Airport *Link*

Request for Project Change

MAY 2008

Queensland
Government

Figure 3-8D
 North Western Connection **Changed** Project Tunnel Connecting Ramps

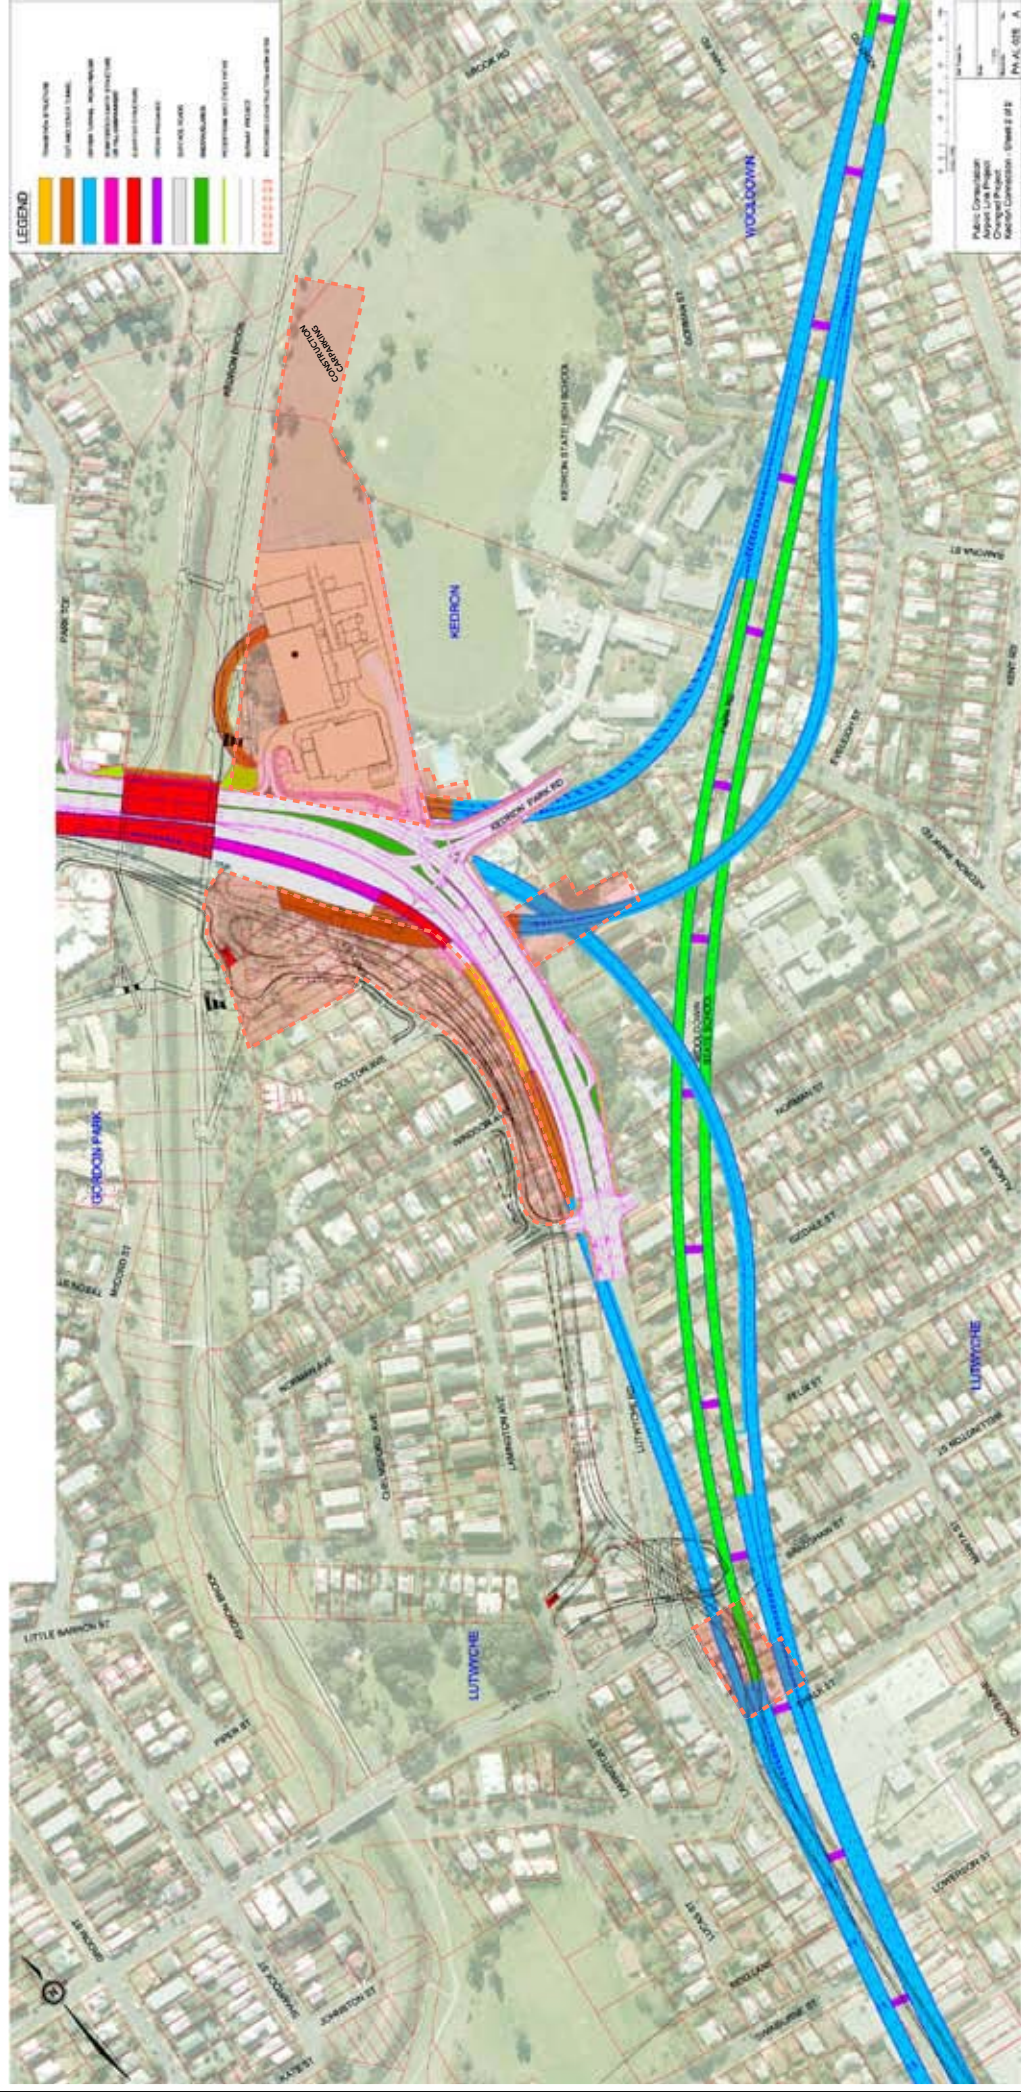
The design of the Kedron connection in the Changed Project also provides for the retention of the DES building south of Kedron Brook with access similar to the existing access from Lutwyche Road. This entry and exit would also provide access to the ventilation station.

A comparison of the Reference Project and Changed Project at Kedron is provided in **Figures 3-7, 3-8A, 3-8B, 3-8C, 3-8D** and **Figure 3-9**.

Figure 3-12
North Eastern Connection **Changed** Project

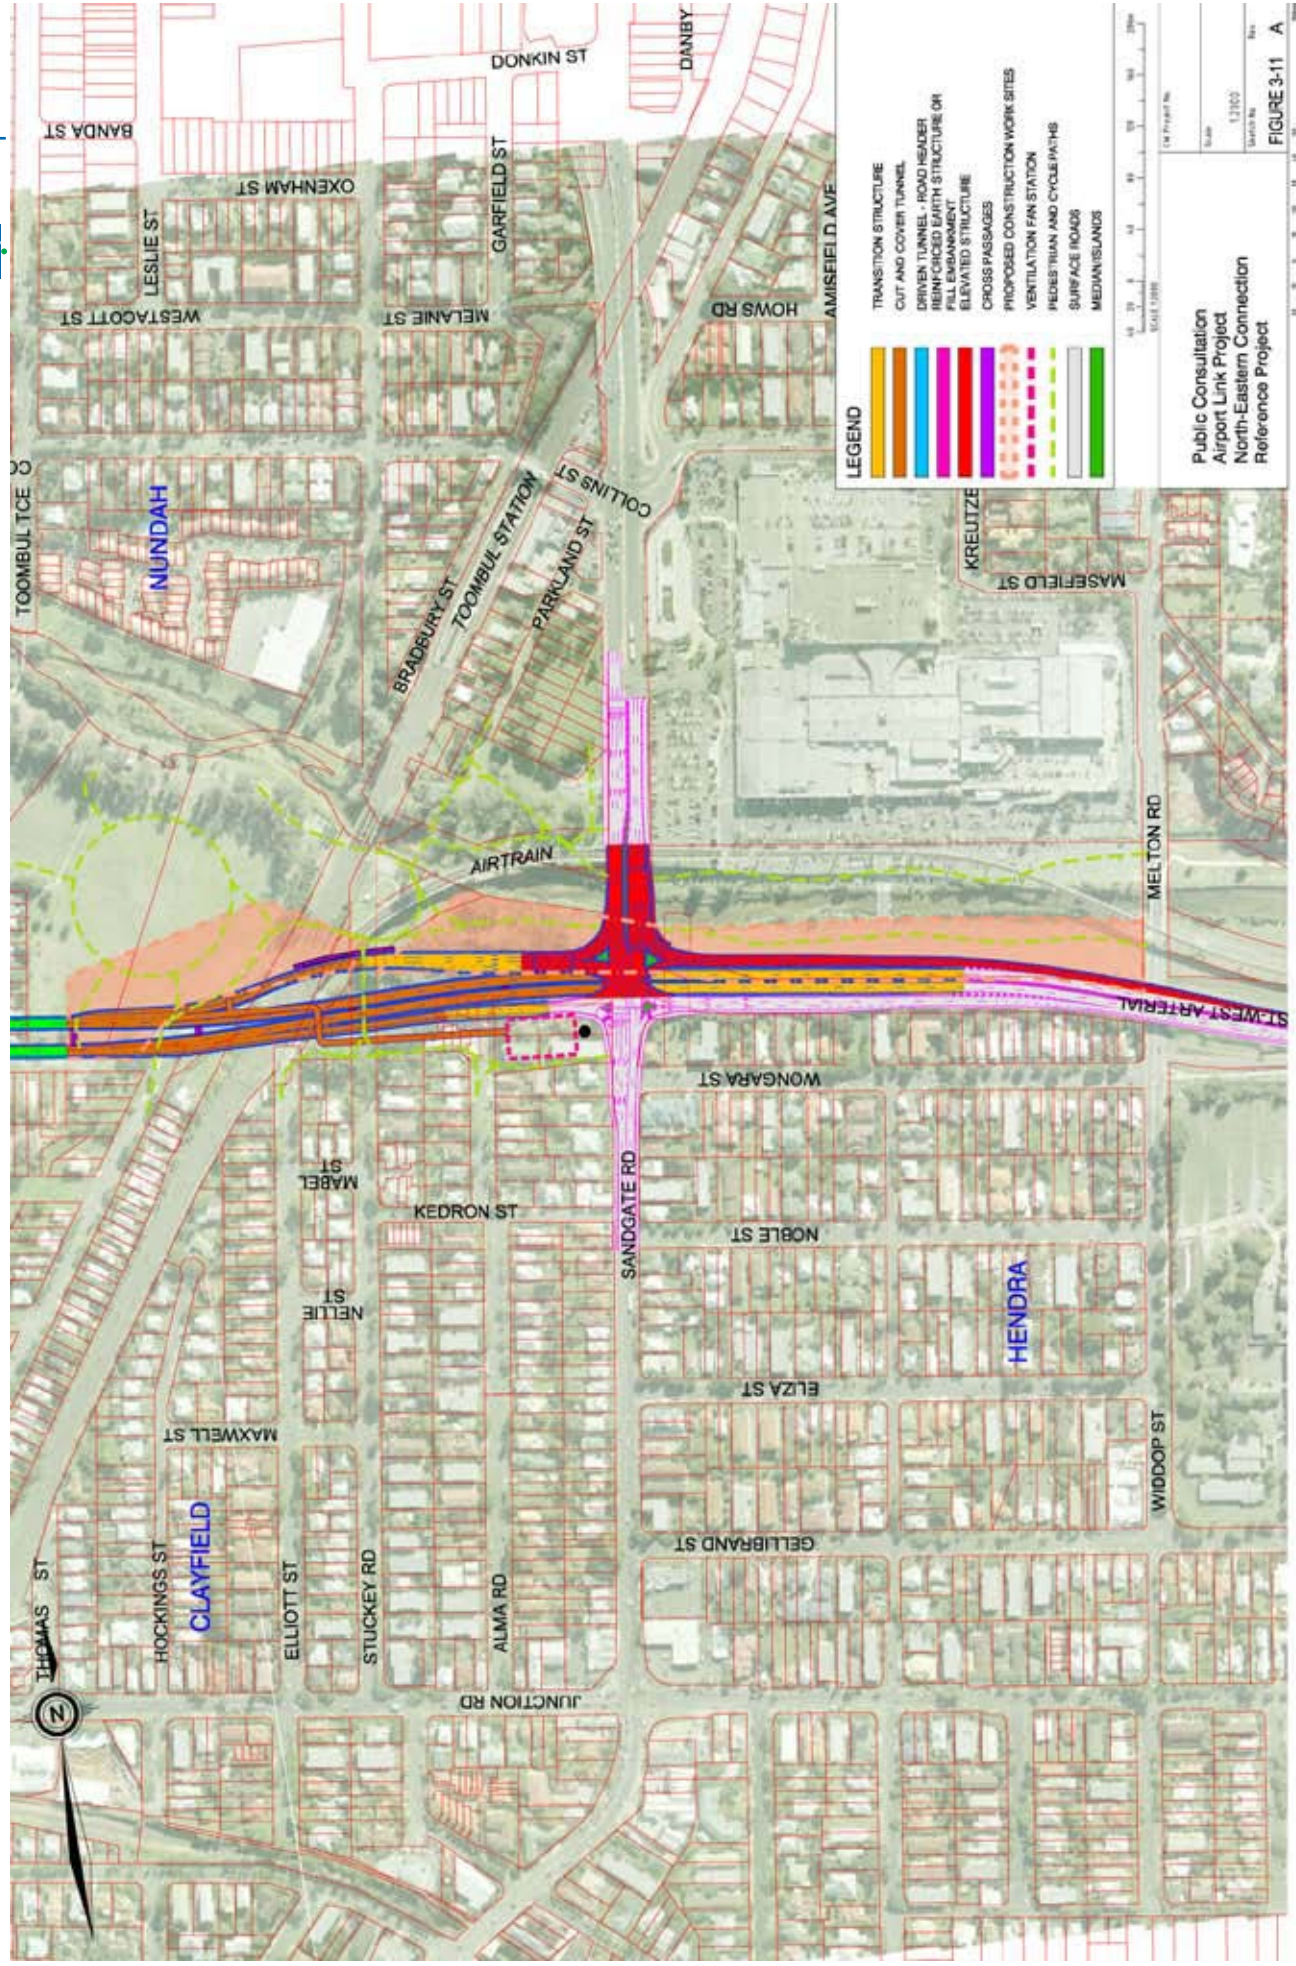
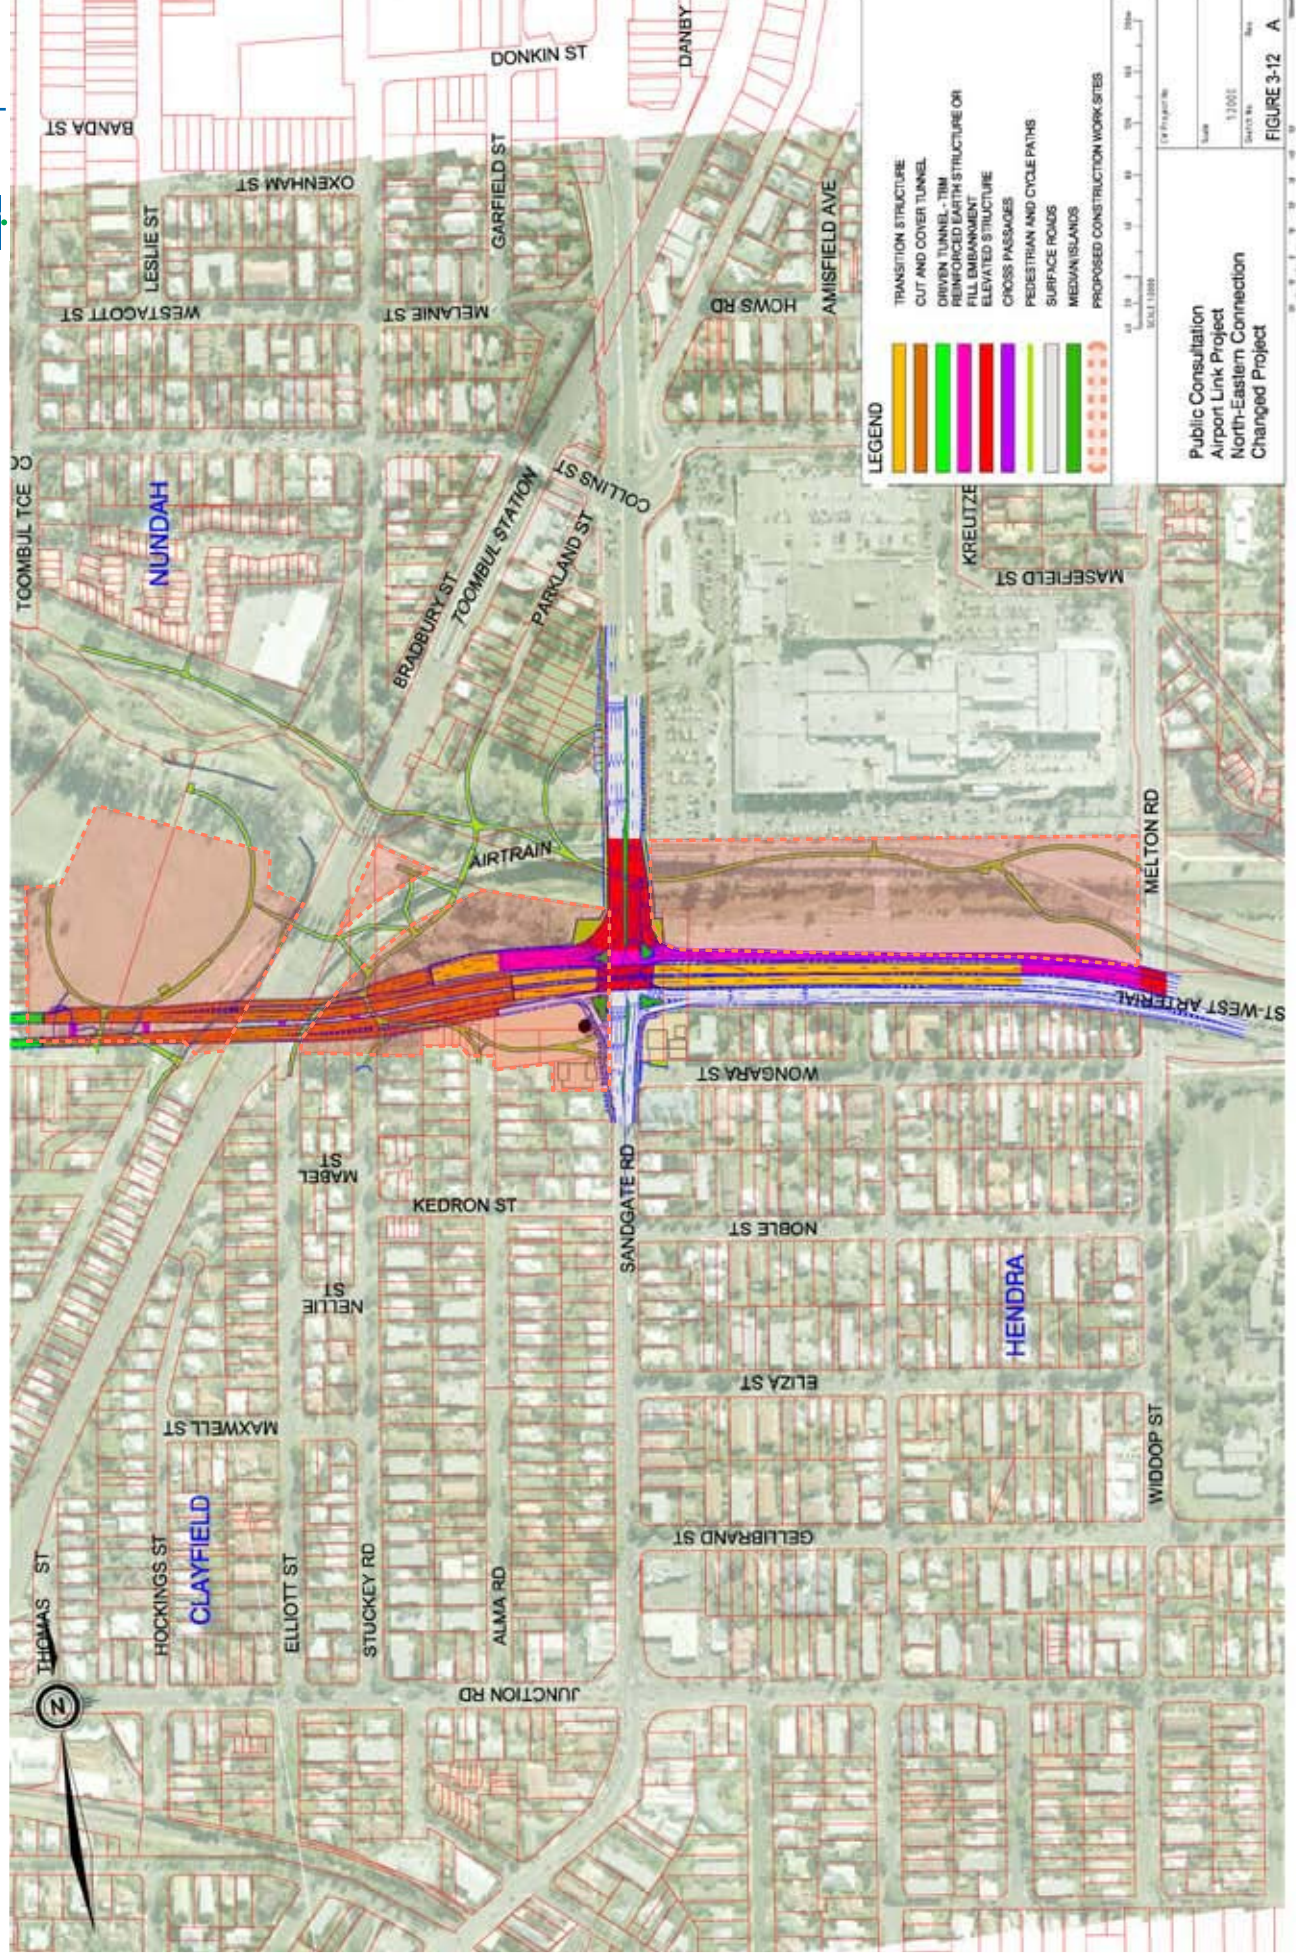
- The ventilation station at Clayfield would be completely below ground level and the ventilation outlet reduced from 30m to 25m in height. The rehabilitated area over the ventilation station would provide parkland and connectivity for pedestrians and cyclists between Clayfield and Toombul.

A comparison of the Reference Project and Changed Project at Kedron is provided in **Figures 3-11** and **3-12**. Two indicative views of this connection are shown in **Figure 3-13**.

Changed Project Landscape View and Section Through Buried Ventilation Station North of Alma Road - Artists Impression

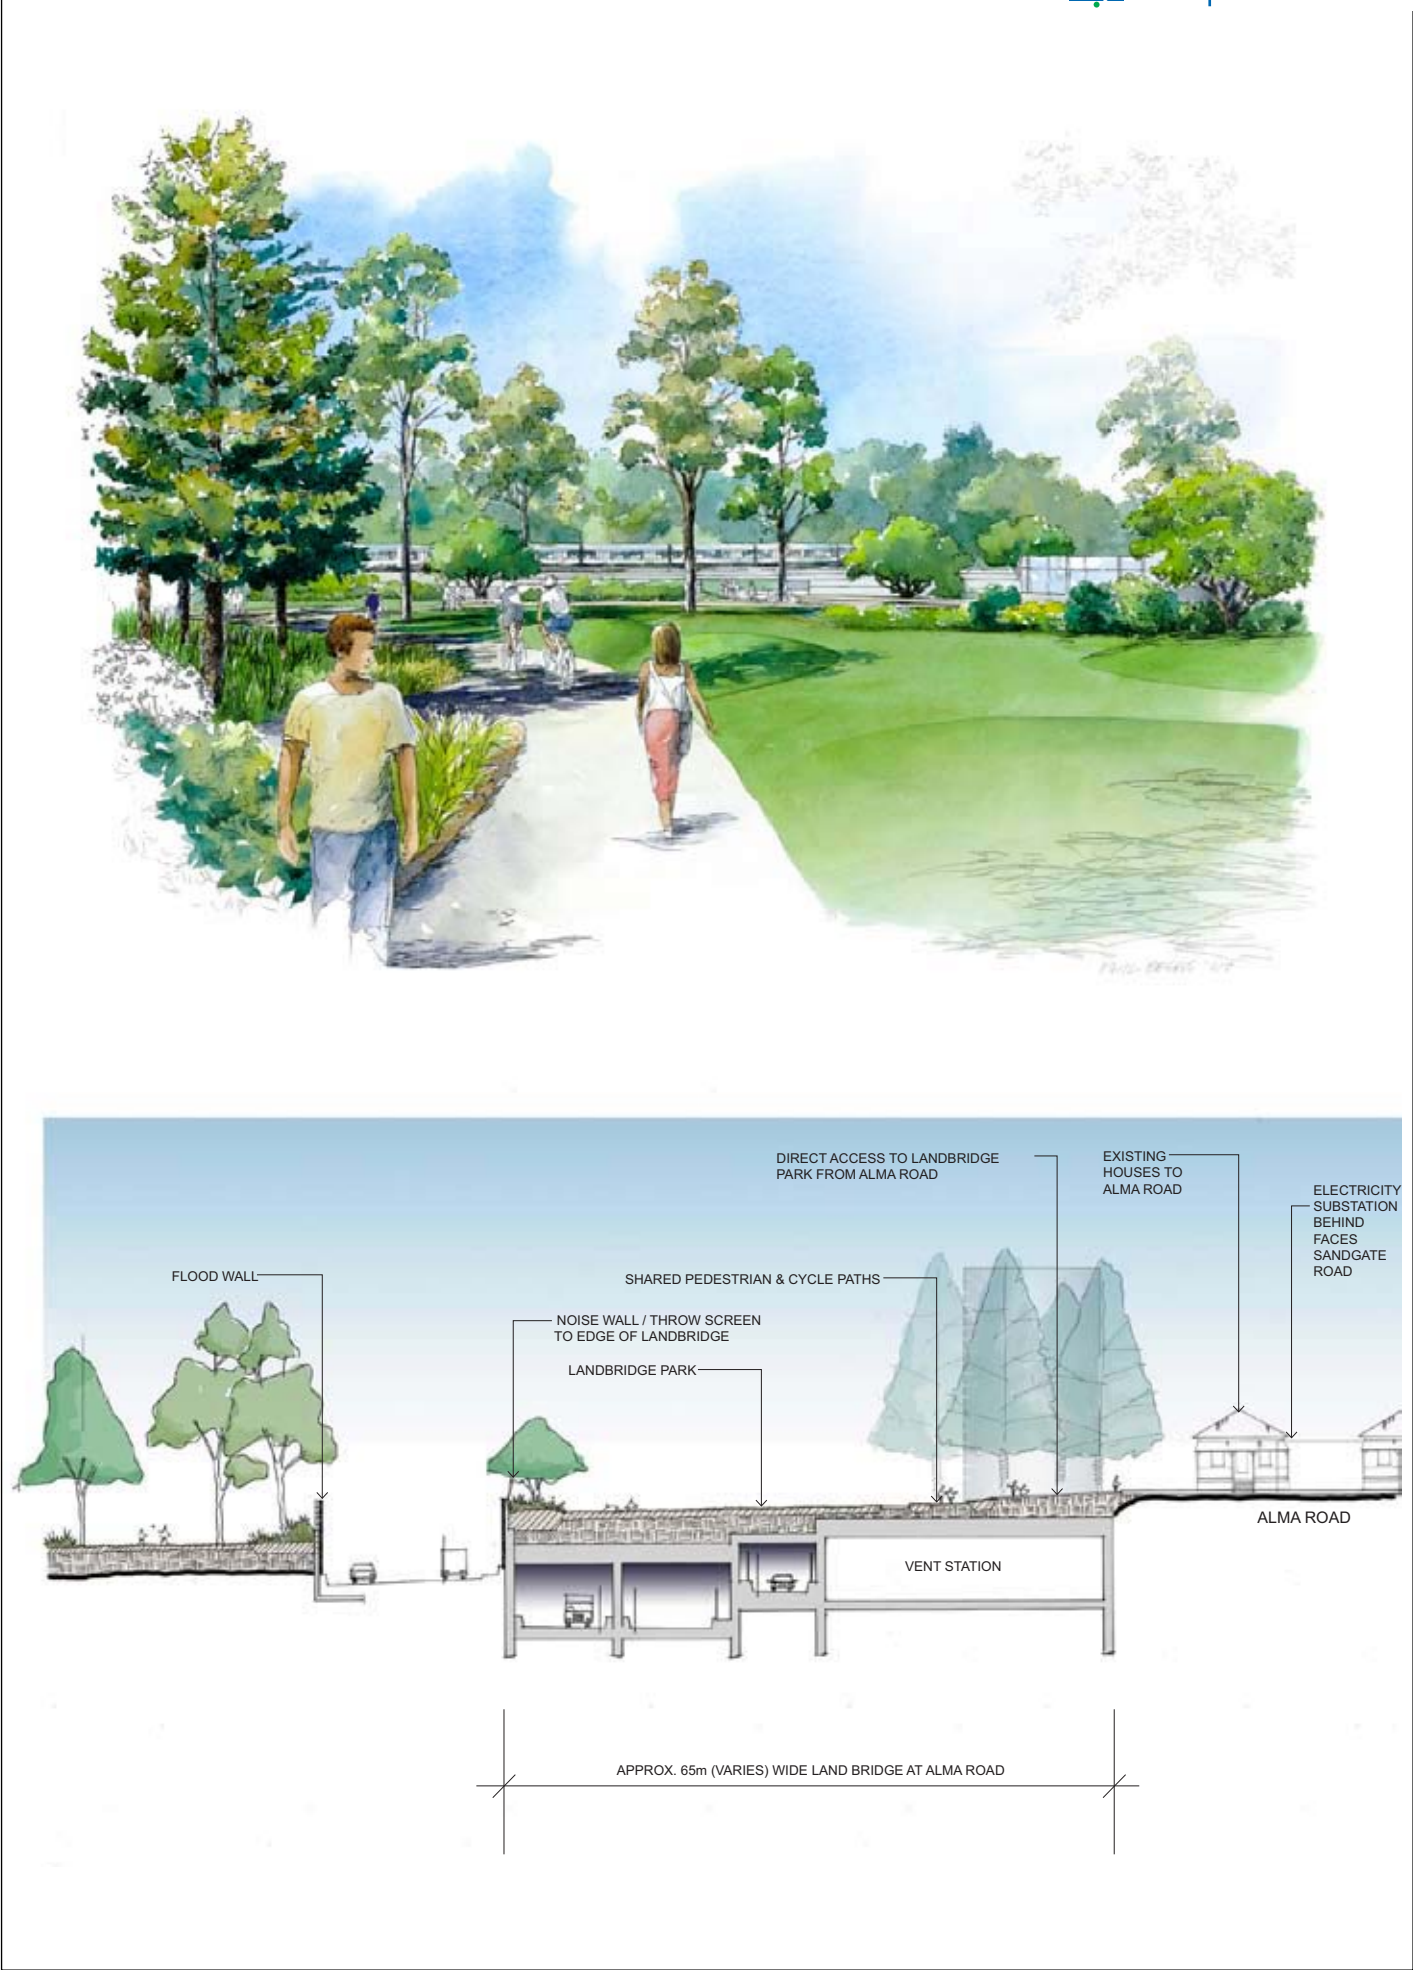
The Clayfield ventilation station would be buried at the same location as the Reference Project. The ventilation outlet would be reduced in height from 30m to 25m in response to community concerns about visual impact and urban amenity. An above-ground electricity sub-station would occupy land south of the below-ground ventilation station. Indicative views of the Clayfield ventilation outlet from surrounding areas are provided in **Figure 3-18**.
